Philco Radio & Television Corp.			
	Model: 42-843	Chassis:	Year: Pre 1945
	Power:	Circuit:	IF:
	Tubes:		
	Bands:		
		Resources	
Riders Volume 14 - PHILCO 14-77			
Riders Volume 14 - PHILCO 14-78			
Riders Volume 14 - PHILCO 14-143

MODELS 42-642,42-843, PHILCO RADIO & TELEVISION CORP.

#### PRODUCTION CHANGES

Filament Resistor Change in Models 42-842, 843, 844, 853, 854

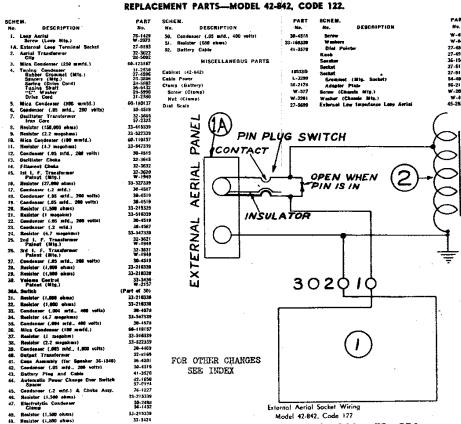
In the above listed models, complaints may be received of a complete set of tubes testing weak. Replacement of the tubes restores normal operation for only a short time after which the same condition re-occurs.

The condition is caused by the overheating of the series filament resistor shown as No. 49 in Service Bulletin No. 391 and as No. 56 in Service Bulletin No. 388. When the overheating takes place, the resistor breaks down, its resistance value decreases, thus allowing an increased filament current to the tubes with resulting damage to the filaments.

An entirely new replacement resistor is available — Part No. 33-3424. This resistor is considerably longer than the one now in the set and is equipped with a protecting cover. The resistor is mounted vertically over one of the original holes in the chassis with a suitable drive screw. The tab on the cover is soldered to the chassis. The longer leads which are required for the installation and which should be fireproof, and not ordinary rubber covered, are brought down through the large hole in the chassis. The other large hole should be plugged up with a spring button, such as Philco Part No. W2232.

Although the Service Bulletin parts listing calls for resistor No. 33-218339, the number of the resistor which has been used is 33-3410. If a replacement is necessary, however, the new resistor No. 33-3424 should be used.

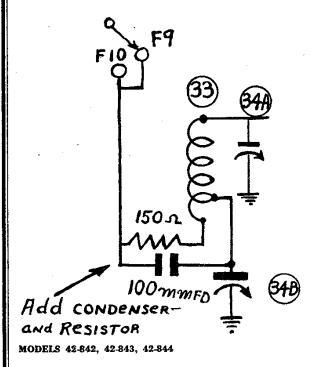
If trouble is experienced in padding the 22 M.C. normal tuning range (compensator 38A), the installation of a 150 ohm resistor Part No. 33-115339 and a 100 mmfd. condenser will improve the operation. These parts are installed in the circuit as shown in the diagram below.
